**SITE PLAN REVIEW COMMITTEE
MEETING AGENDA**

DATE: Thursday, December 15, 2016
TIME: 7:00 – 9:00 p.m.
PLACE: 2100 Clarendon Boulevard
Conference Rooms C & D
Arlington, VA 22201

Item 1. Ballston Station (SP #443) 7:00pm–9:00pm
(RPC#s 14-024-001, -004, -017, -018, -019)
Planning Commission and County Board meetings to be determined.
Michael Cullen (CPHD Staff)

ITEM 1
Ballston Station (SP #443)
(RPC#s 14-024-001, -004, -017, -018, -019)

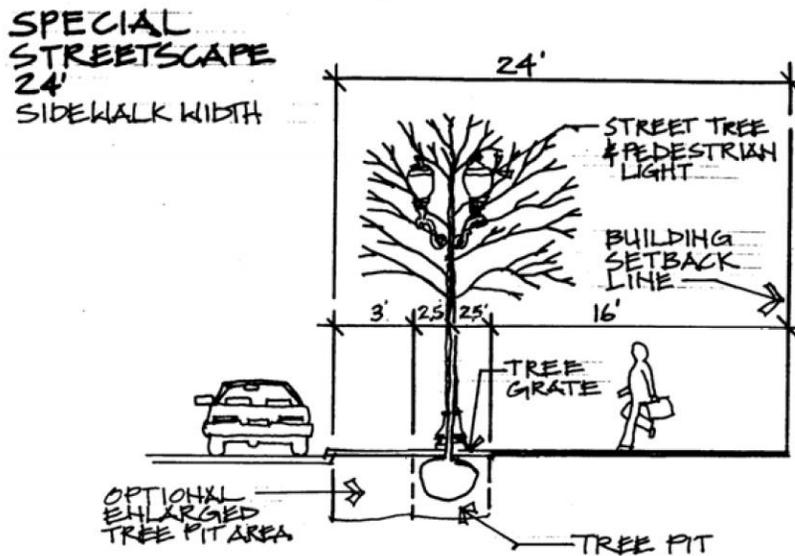
The proposed design was revised to carve out an approximately 325 square foot area to preserve the Robert Ball Sr. Burial Ground. The carve-out closely lines the estimated limits of the burial ground, and the building overhangs approximately two-thirds of the burial ground

area with six residential units above. At the direction of the County Board, staff anticipates the burial ground's designation as a local historic district concurrently with the site plan approval. The current design does not appropriately consider this designation in context, and does not appropriately consider the sanctity of the burial site. Staff does not support any overhang of the building over the burial ground area that would be subject to historic designation.

Staff supports the proposed incorporation of the Tiffany stained glass window into the façade as a public art benefit, but the current design does not provide public access to the Tiffany window. Access should be provided, preferably, by open space access around the fenced in burial ground site so that it may be appreciated as a public amenity.
